Layhill Primrose, Conditional Use No. CU 17-16

Staff Report Completed: 4-2-18

Description

Request for approval of a Day Care Center (over 30 persons) for up to 200 children, with the public hearing by the Hearing Examiner scheduled for May 4, 2018.

Figure 3: Conditional Use Plan

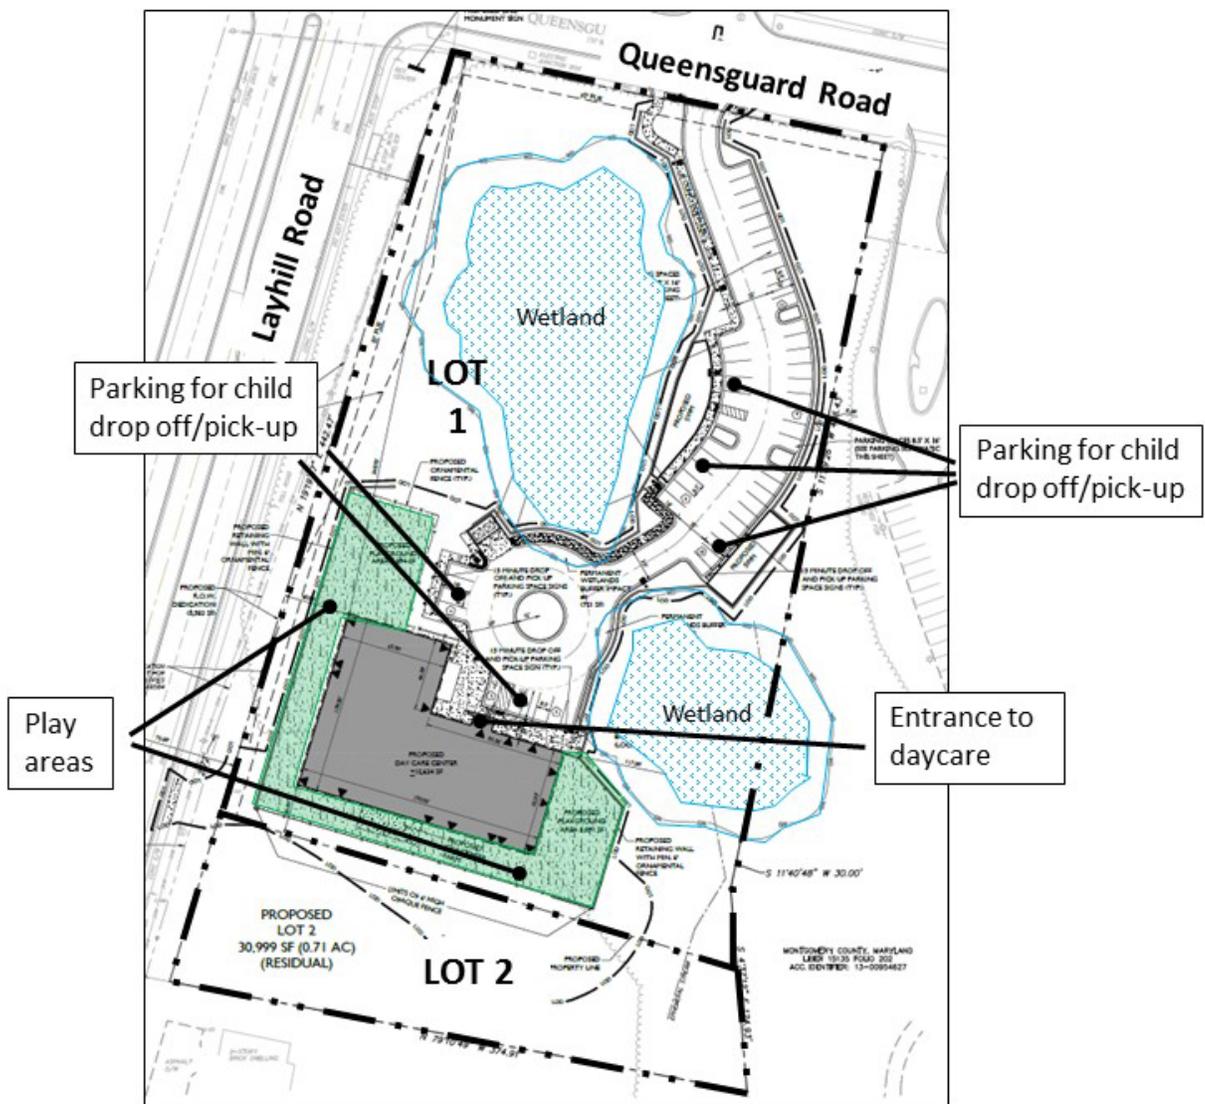
1. We have concerns related to the spacing of driveways on Queensguard Road. The proposed driveway is very close to an existing driveway of a Community Center. The proposed driveway is only 100 ft. +/- from Layhill Road. A deceleration/turn lane could be a remedy. In addition, a center turn lane could also be implemented to handle left turns out of the proposed site and the Community Center.
2. We also have concern regarding the vehicular movements on Queensguard Road. Please provide a Queuing Analysis for Queensguard Road at Preliminary Pan stage.

12. At Preliminary Plan, the Applicant must:
 - a. Provide a queuing analysis for Queensguard Road. Additional improvements, including a left and right turn lane on Queensguard Road, may be required to provide for adequate queuing;
